Re: Draft EIR/EIS for Contra Costa Water District's
Alternative Intake Project

These comments are submitted on behalf of both the Central Delta Water Agency and Reclamation District No. 2040.

EXHIBIT ES-3

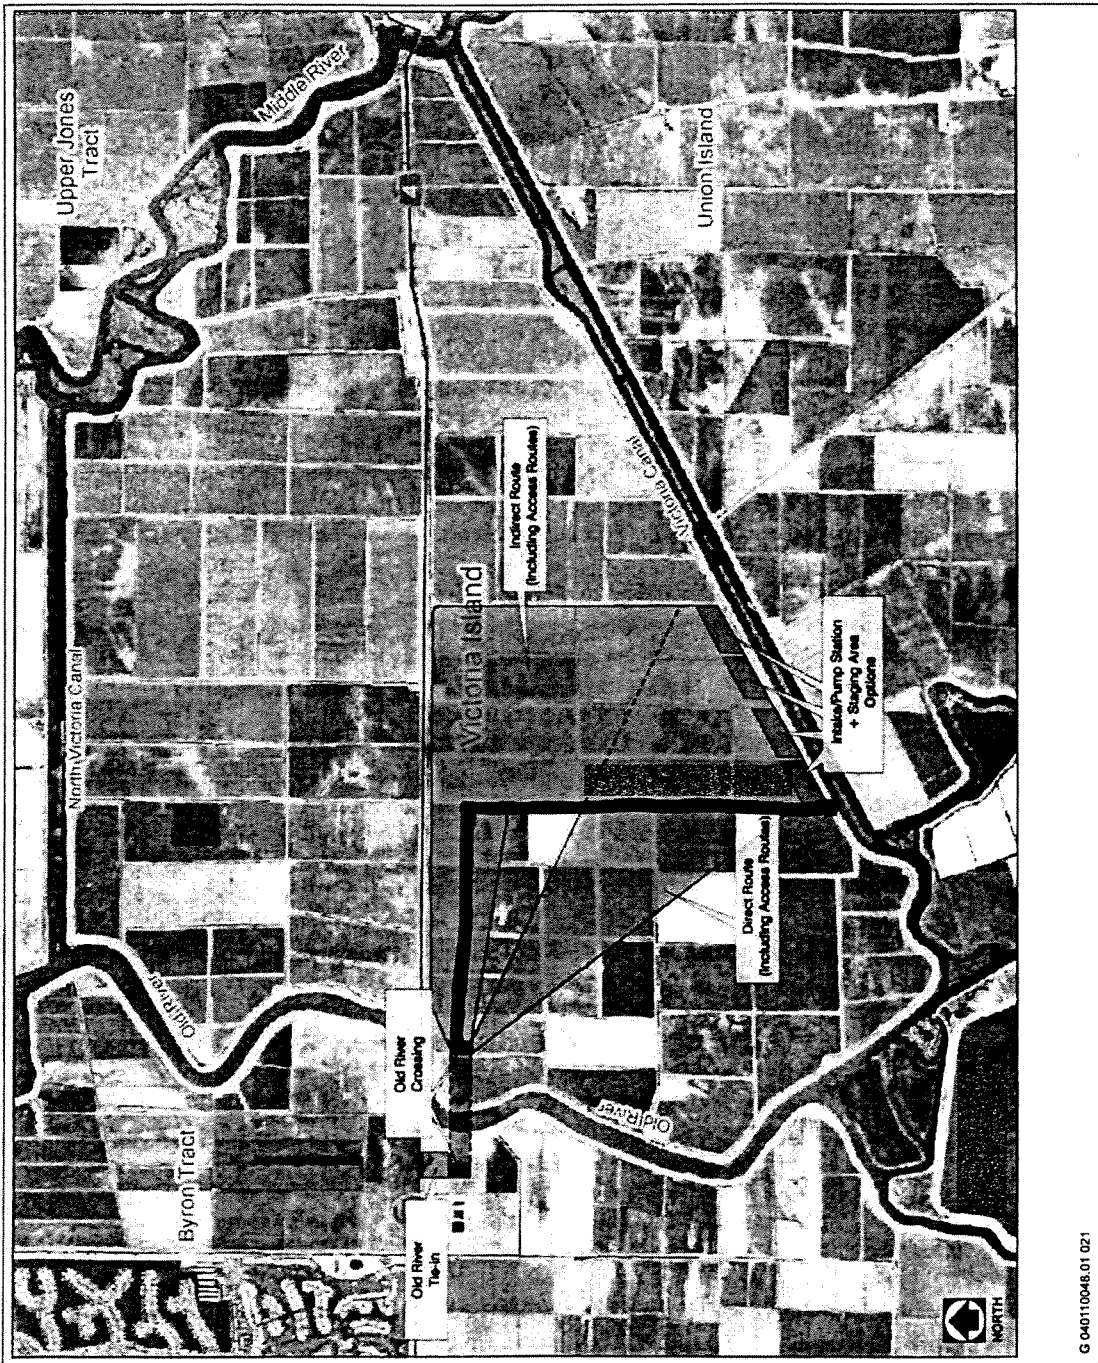
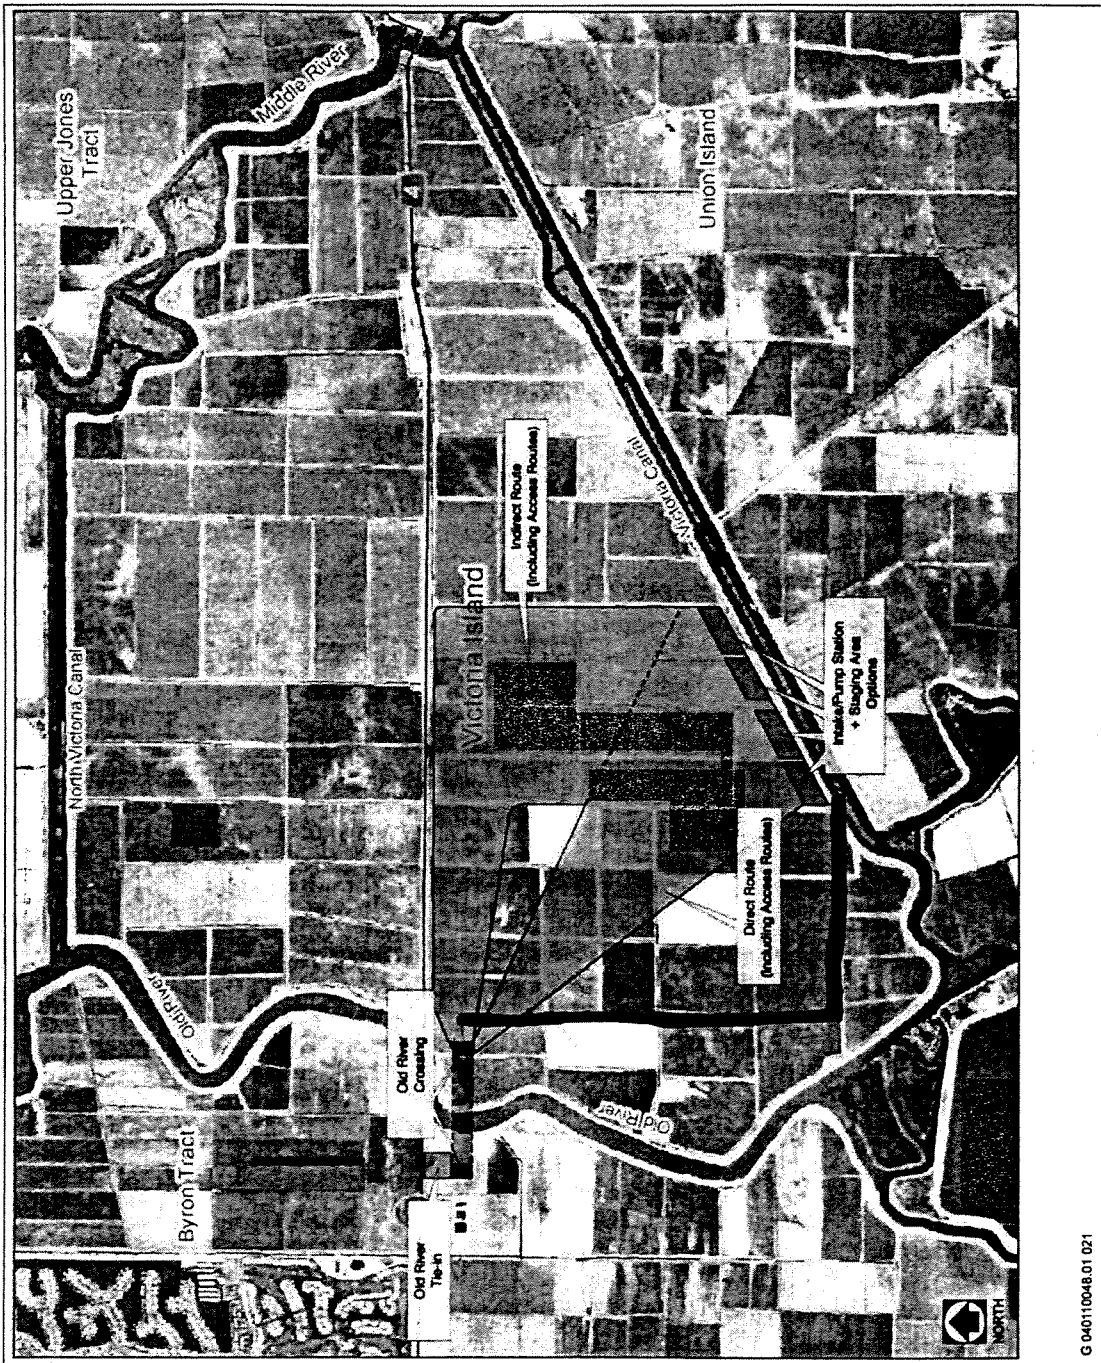
DEIS Exhibit ES-2 shows that for many months of the years Old River water quality is better than that at Victoria Canal. Could the CCWD objectives be better fulfilled by simply exercising Area of Origin (WC 11460, et seq.) priorities to divert more water during the periods of good water quality at Old River? This could eliminate the expense for a new intake on Victoria Canal.
